MEMORANDUM

TO: Historic Preservation Board
 FROM: Merrillyn C. Rathbun, Fort Lauderdale Historical Society
 SUBJECT: Agenda for December 5, 2016
 DATE: November 29, 2016

Case	H16015	FMSF#	
Review and Comment	Henry F. Kinney Tunnel/Tunnel Pedestrian Plaza		
Owner	FDOT/City of Fort Lauderdale		
Developer	City of Fort Lauderdale/Elizabeth Van Zandt		
Address	SE 6th Avenue/Las Olas Blvd. Tunnel		
General Location	Intersection of East Las Olas Boulevard and South Federal Highway		
Legal Description	<p>A PORTION OF RIGHT OF WAY AT THE INTERSECTION OF EAST LAS OLAS BOULEVARD AND SOUTH FEDERAL HIGHWAY IN SECTION 11, TOWNSHIP 50 SOUTH, RANGE 42 EAST MORE PARTICULARLY DESCRIBED AS FOLLOWS:</p> <p>BEGIN AT THE NORTHEAST CORNER OF TRACT 2, "BURNHAM'S SUBDIVISION", ACCORDING TO THE PLAT THEREOF, RECORDED IN PLAT BOOK 15, PAGE 29, OF THE PUBLIC RECORDS OF BROWARD COUNTY, FLORIDA; THENCE SOUTH 87°34'20" WEST ALONG THE NORTH LINE OF SAID TRACT 2 AND ALSO BEING THE SOUTH RIGHT OF WAY LINE OF EAST LAS OLAS BOULEVARD, A DISTANCE OF 23.00 FEET; THENCE NORTH 02°33'11" WEST, A DISTANCE OF 80.00 FEET; THENCE NORTH 88°05'12" EAST, A DISTANCE OF 36.70 FEET; THENCE NORTH 01°54'48" WEST, A DISTANCE OF 75.0

Fig. 1 Tunnel slip road, U.S. 1, looking north

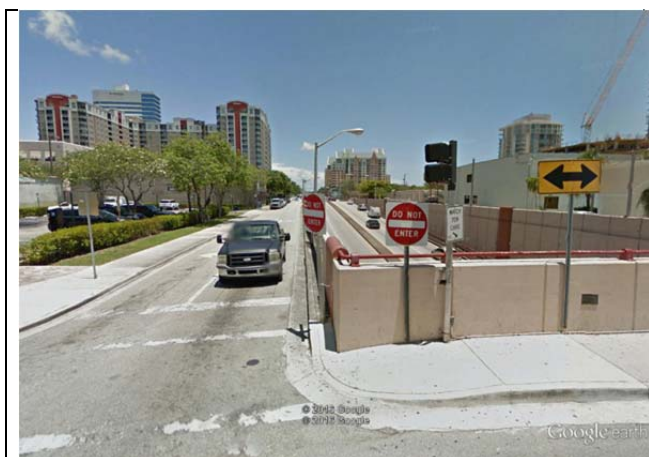
Description of the Project: The applicant has brought a project to the Board to build a pedestrian plaza on top of the NR¹ eligible Henry F. Kinney tunnel. The project would involve structural changes to the tunnel. Presently, according to the applicant's report, an auto driver's sight, approaching the intersection at Las Olas Boulevard, is blocked by the height of the tunnel wall from seeing an approaching pedestrian trying to cross at the slip road.

Fig. 4. S.E. 9th Avenue street end, Collee Hammock

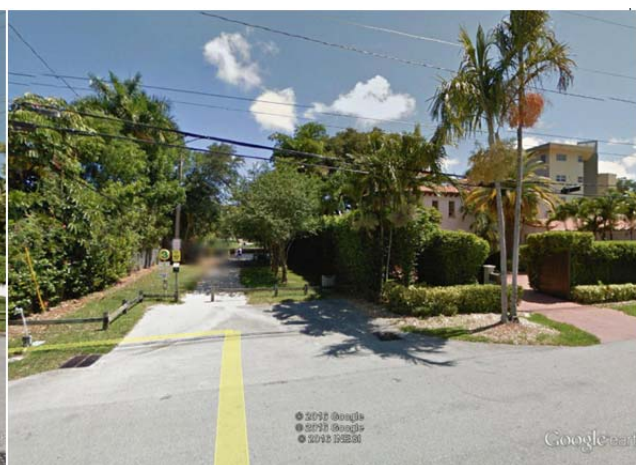
When the tunnel was under construction (1958-1960) traffic from U.S. 1 was diverted to temporary bridges at S.E. 5th Avenue, southbound, and S.E. 9th Avenue northbound³. The S.E. 3rd Avenue bridge was under construction at that time. To this day the street ends at S.E. 9th Avenue in the Rio Vista neighborhood on the south side of the New River and in Colce Hammock on the north side have remained open in case there is any need to divert traffic from the tunnel. Now some of that traffic would probably be diverted to the S.E. 3rd Avenue Bridge; however the 9th Avenue option might still be needed.

Figure 1. Showing National Register-listed properties, no. 1 Bryan Building and no. 2 New River Inn; Proposed development and H-1 Historic District (small buildings left side of picture) showing contributing properties and The Shippey House and the Replica Schoolhouse.

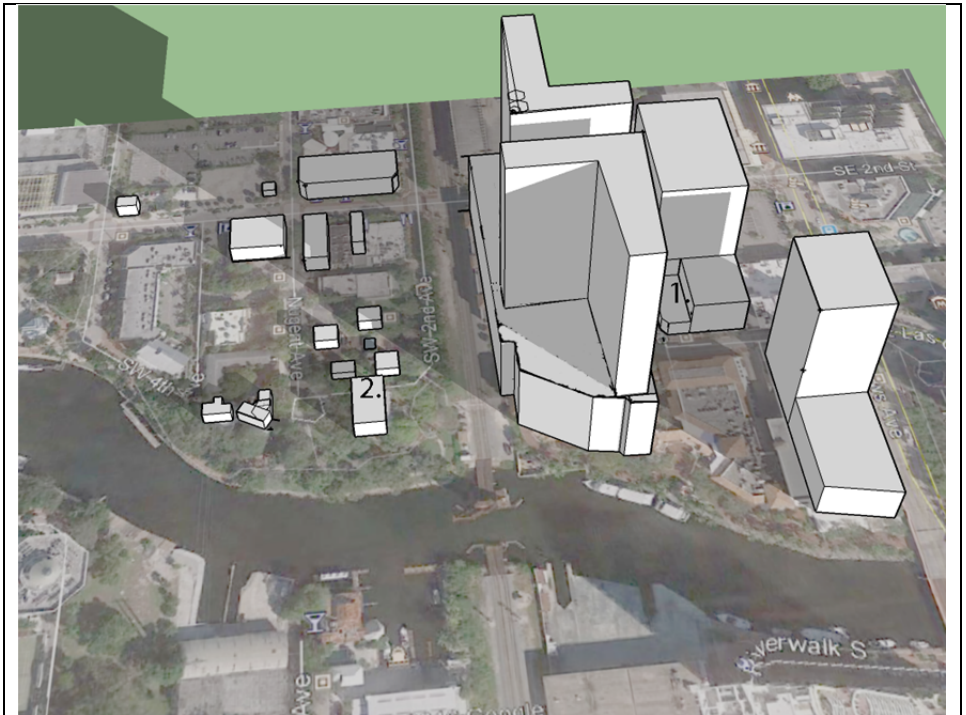
The proposed project is across Brickell Avenue from the NR-listed Bryan Building (Fig. 1, no. 1) and is adjacent to the locally designated H-1 Historic District.

New construction in the H-1 District is limited to 25 feet in height; the tallest building in the district is probably the NR-listed New River Inn at approximately 36 feet. The massive 41-story Riverfront project will create an immense wall effect effectively isolating the historic district from the downtown. A person standing on the front porch of the contributing Philemon Bryan Home would not be able to see the top of this project.

Figure 3. Shadow effect on NR Listed Bryan Building

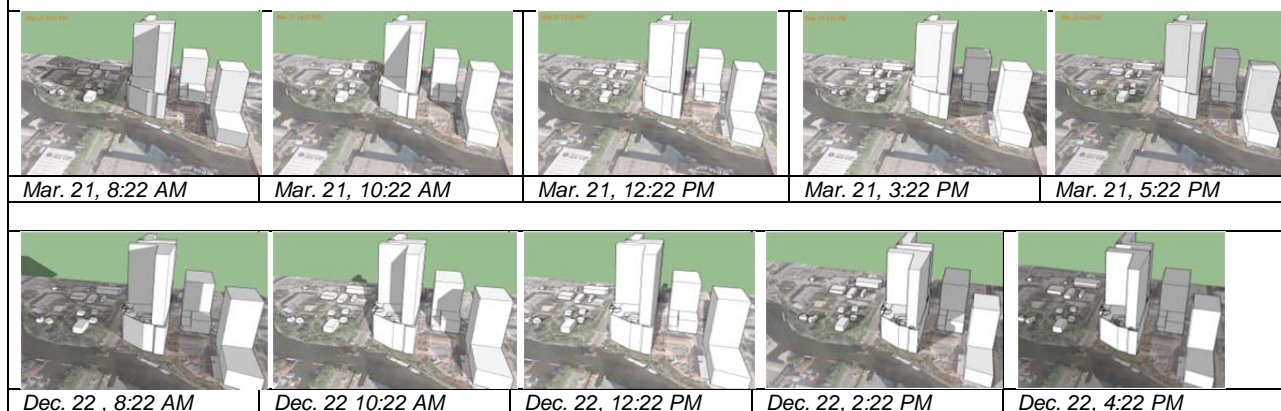
The Bryan Building on Brickell Avenue would have a serious shadow impact at various times of the year (see Fig. 3). The adjacent sixteen-story bank building would be affected; its façade, the western elevation, could be completely in shadow at times.
